UNITED STATES
NUCLEAR REGULATORY COMMISSION
WASHINGTON, D. C. 20555

ARKANSAS NUCLEAR ONE, UNIT NO. 2

AMENDMENT TO FACILITY OPERATING LICENSE

Amendment No. 5
License No. NPF-6

Figure 6.2-1 Management Organization Chart

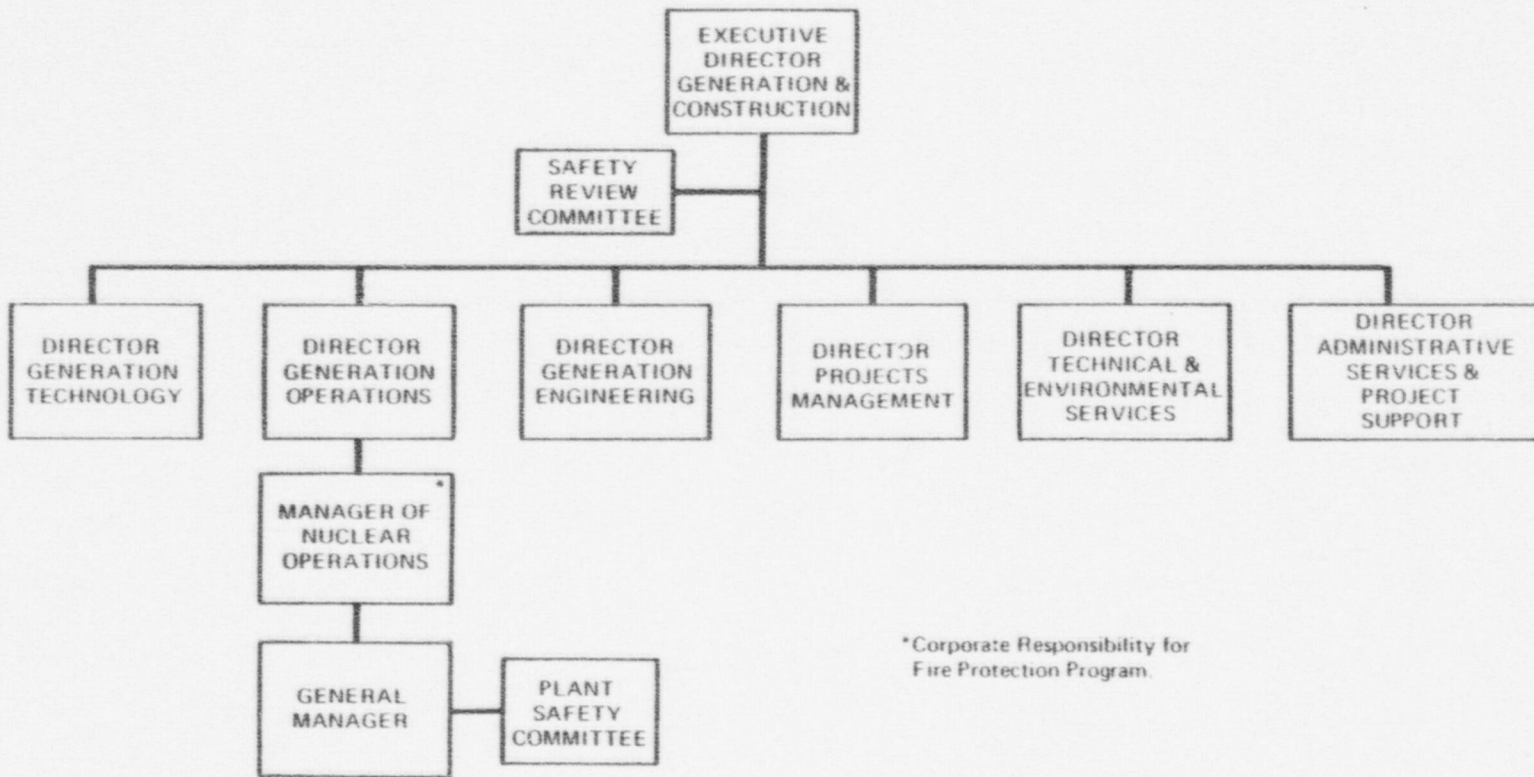
6.2.1 The offsite organization for facility management and technical support shall be as shown on Figure 6.2-1.

Figure 6.2-2 Functional Organization for Plant Operation

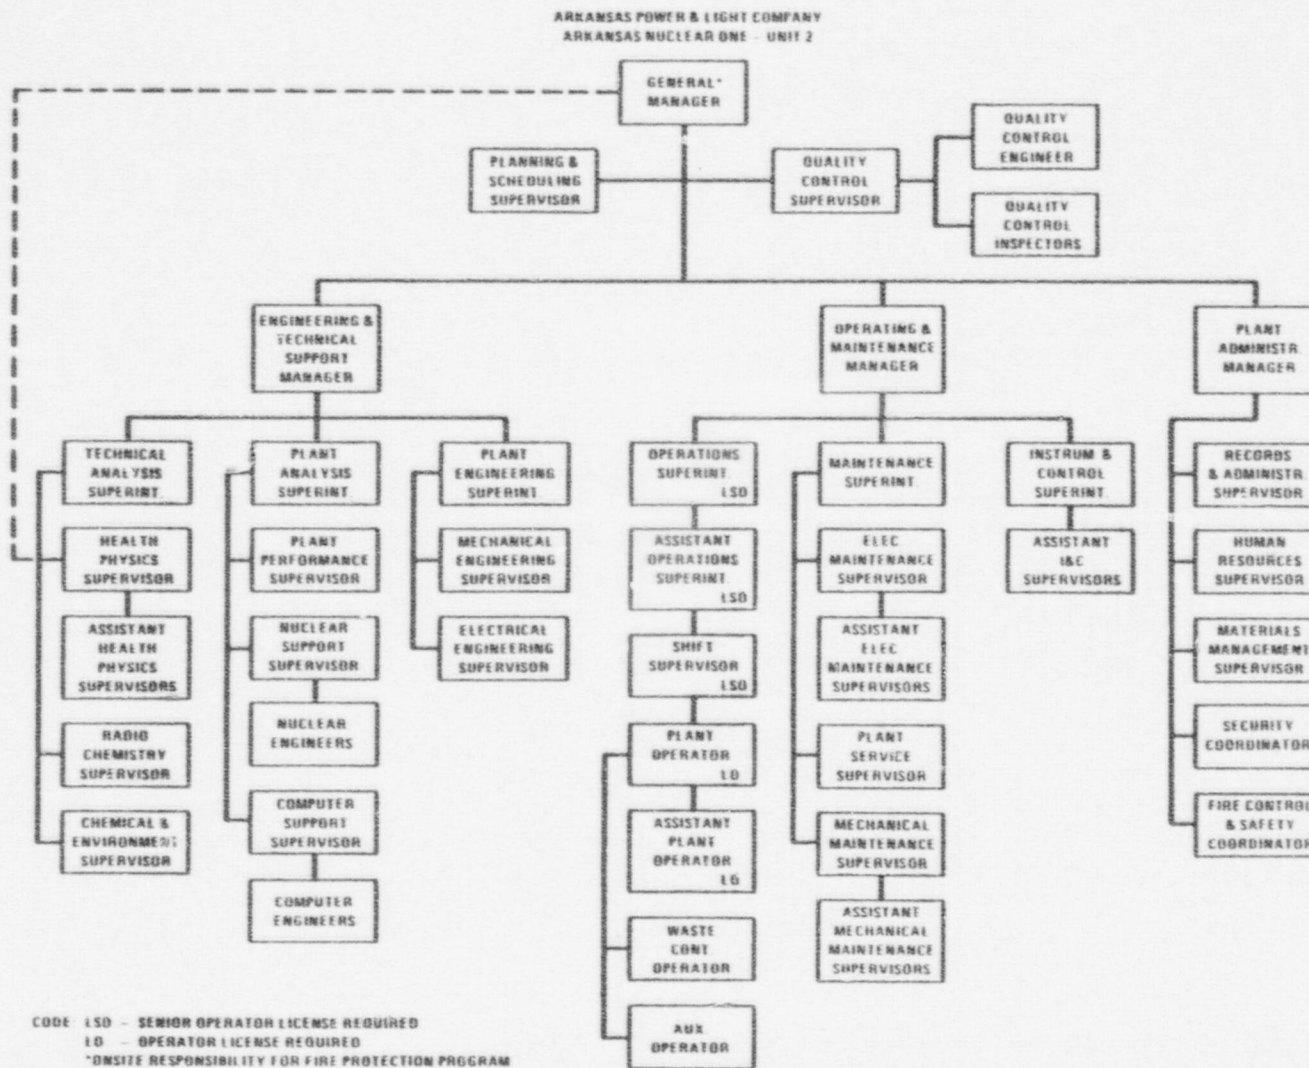
6.2.2 The Facility organization shall be as shown on Figure 6.2-2 and:

FIG. NO.
5-1

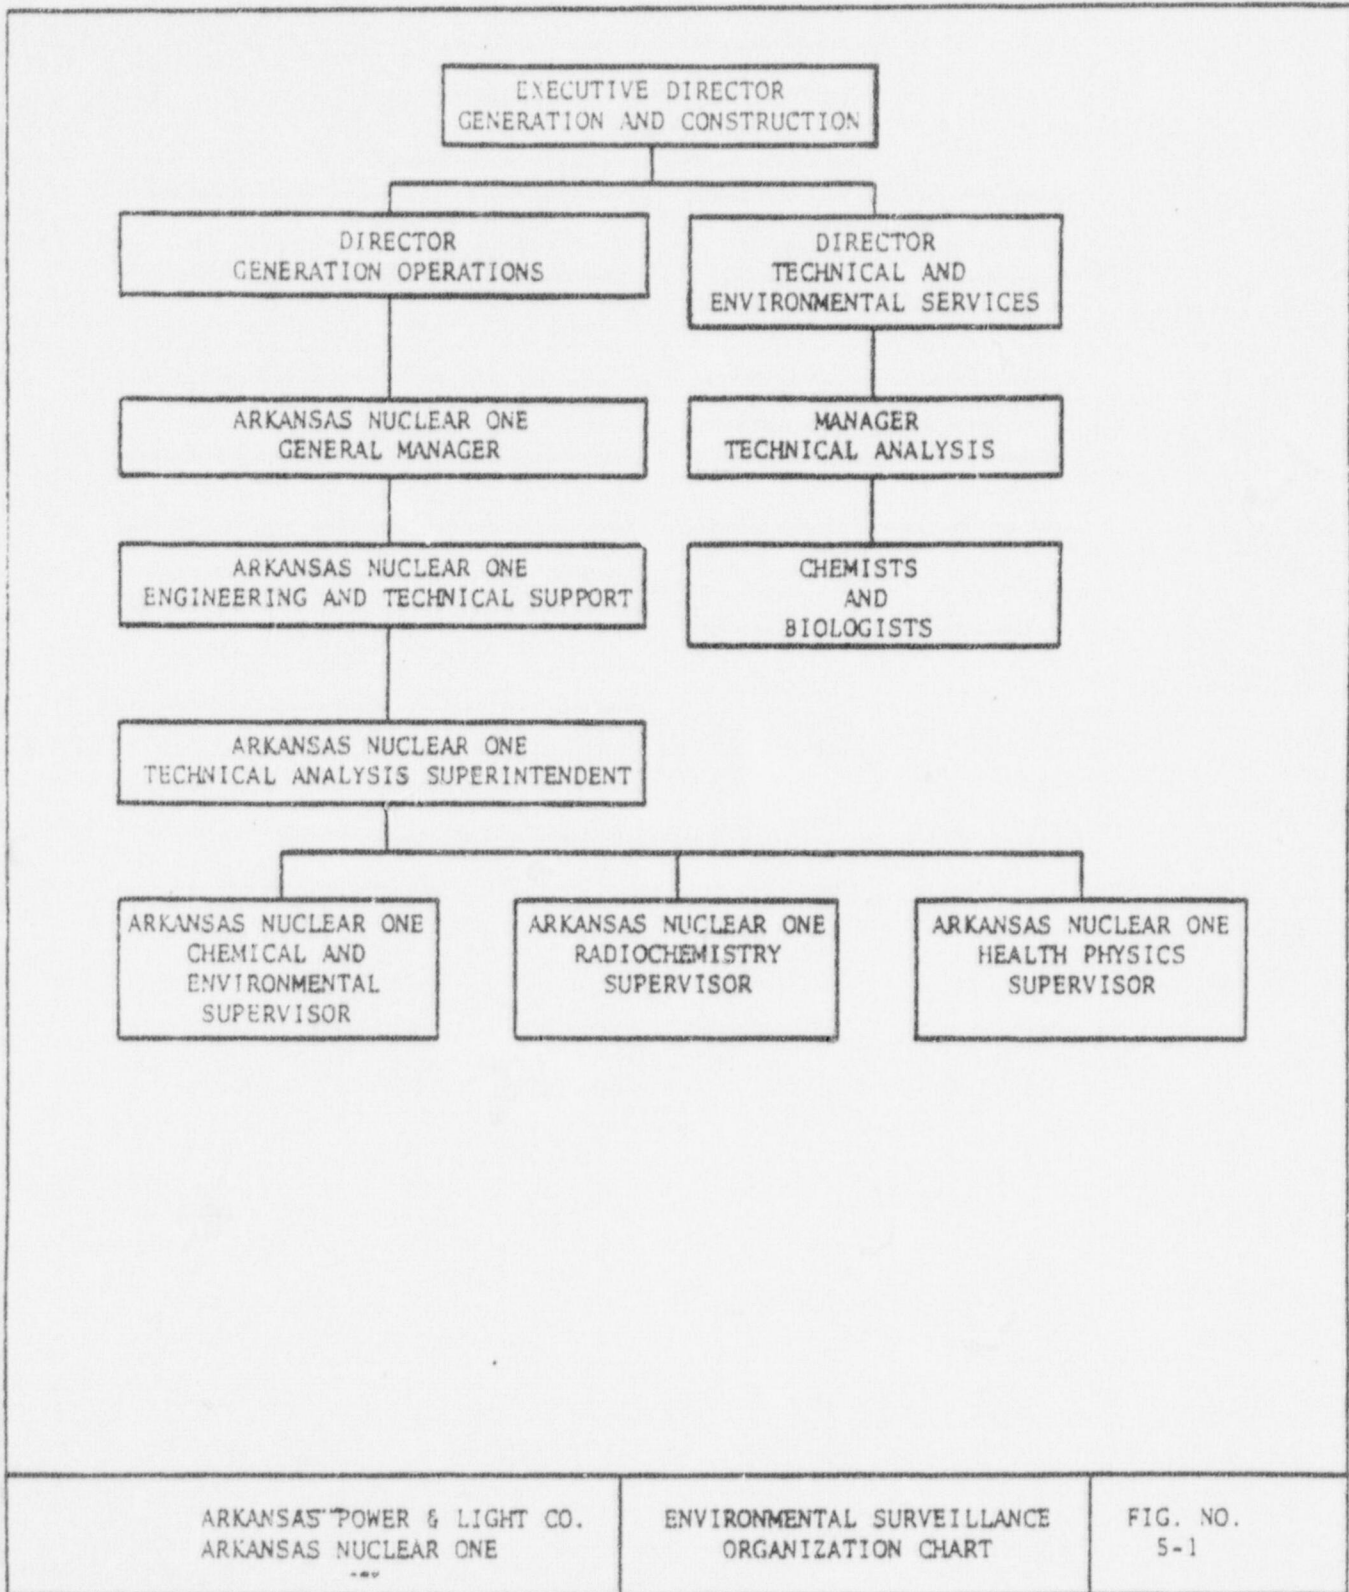
Figure 5-1 shows the organization chart at both plant and corporate levels relative to environmental matters.
